DEVELOPMENT FACILITATION TEAM (DFT) APPLICATIONS

Re: EPC Conditions of Approval, PR-2023-009356, SI-2023-01631 – Site Plan - EPC

RE: PR-2024-010191 SI 2024-00471 - Site Plan- EPC for an Extraordinary Facility

City of Albuquerque Open Space Division PO BOX 1293 Albuquerque, NM 87103 **Project # PR-2023-009356** SI-2023-01631 - Site Plan - EPC

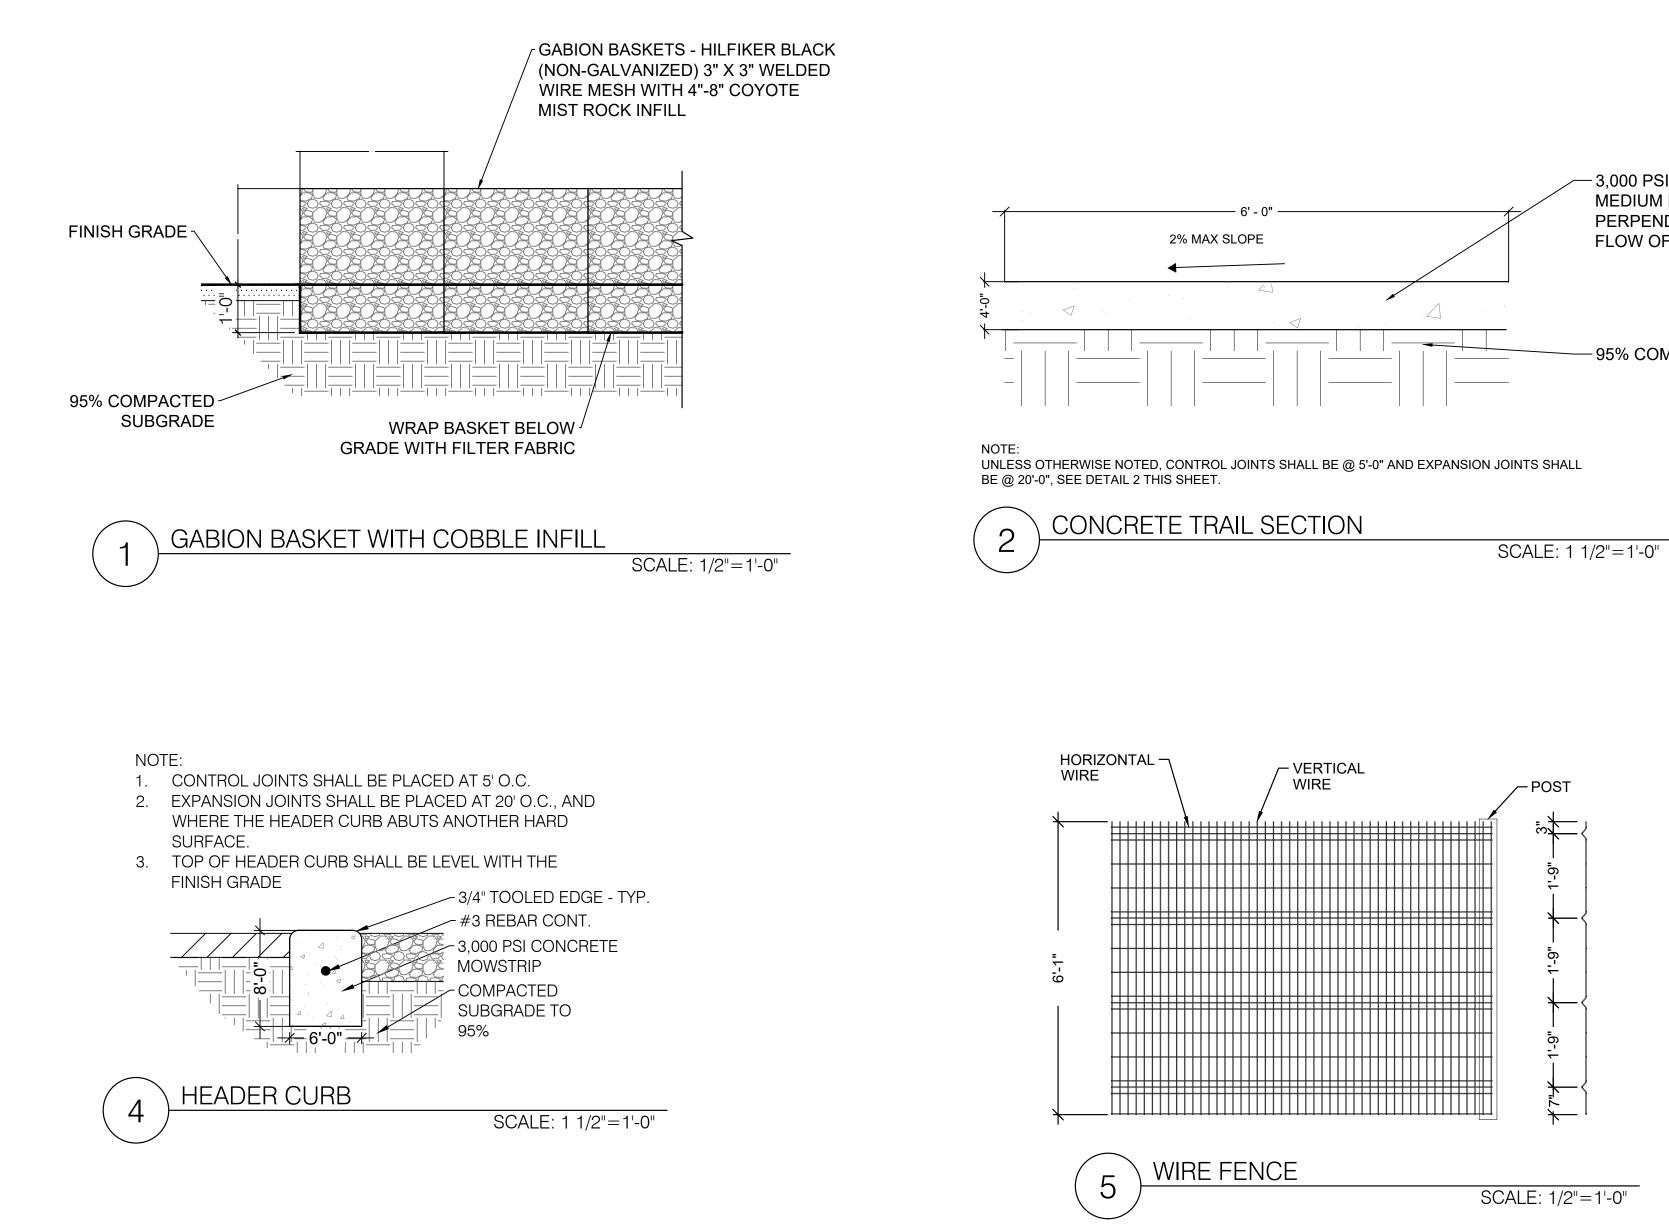
4. Detail Sheet: The general note on the detail sheet shall be revised to remove the statement that a trash bin will not be located on site. There are trash receptacles proposed on the site plan and a detail has been provided.

Applicant Response: The notes on the detail sheet have been revised.

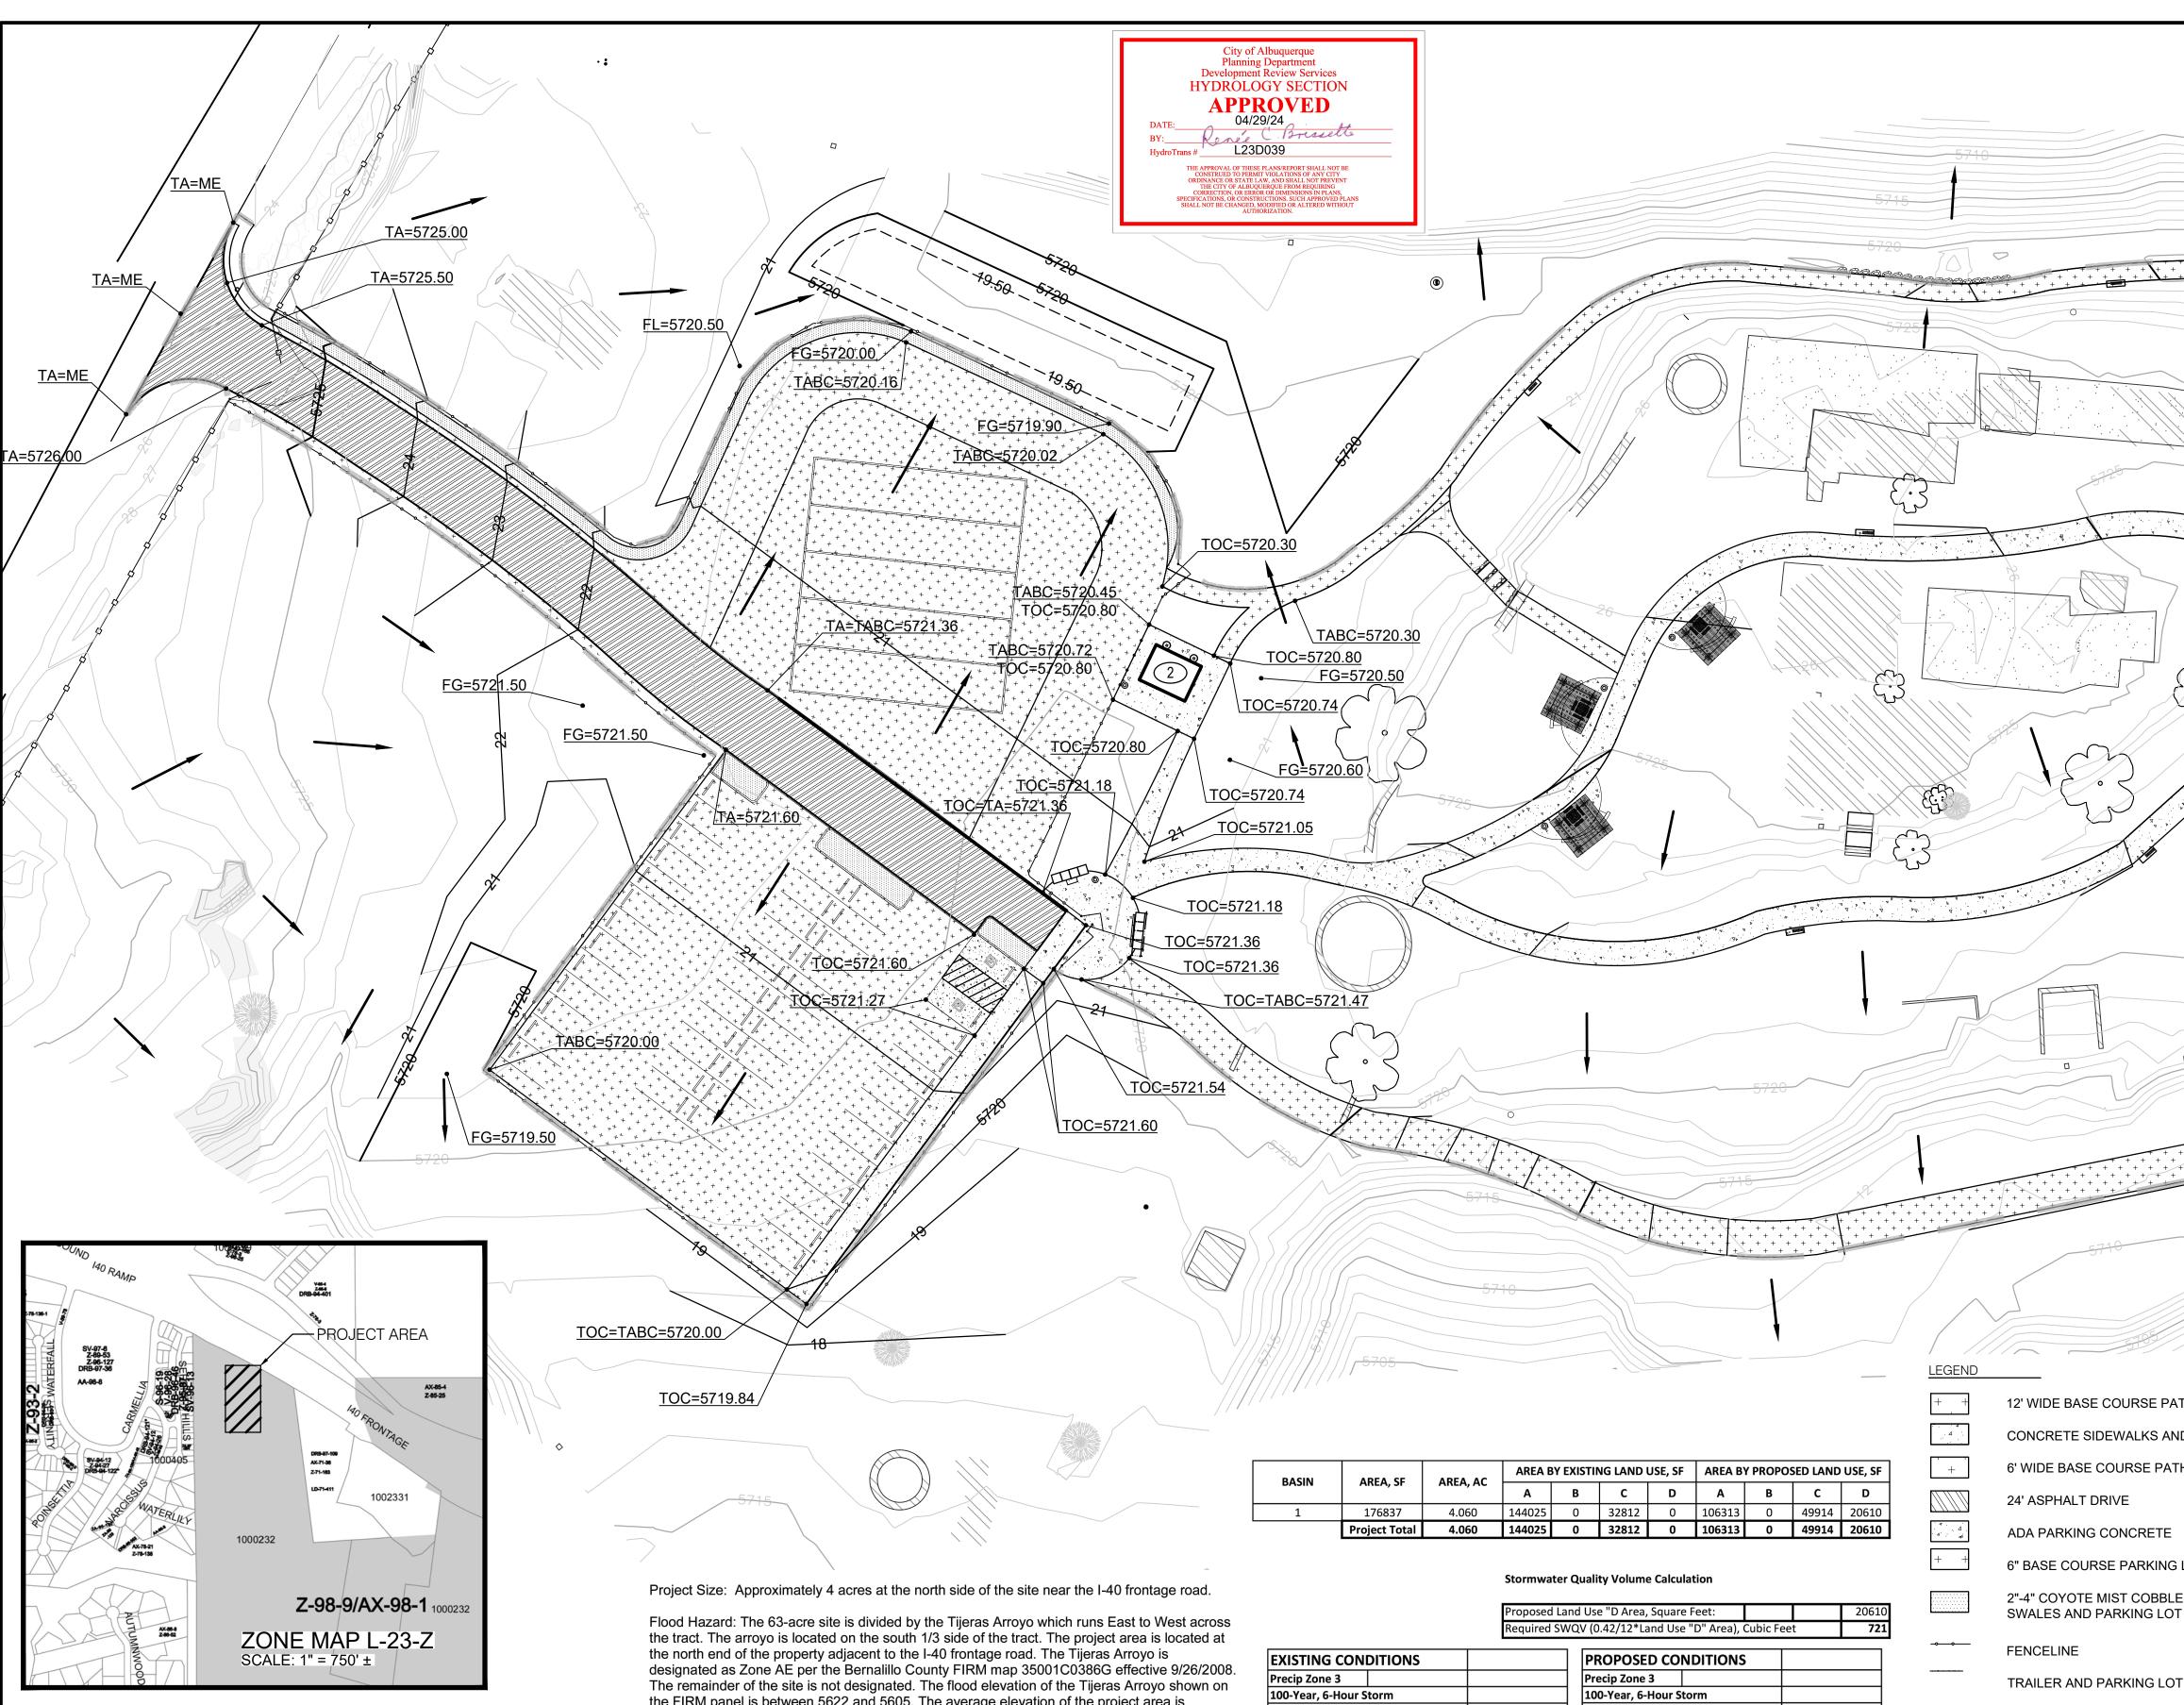
5. Conceptual Grading and Drainage Plan: The vault toilet shall be moved to the proposed future location on the NE corner of the equestrian parking lot agreed upon by the applicant.

Applicant Response: It was agreed that the proposed future vault toilet shall be moved to the SE corner of the equestrian parking lot.
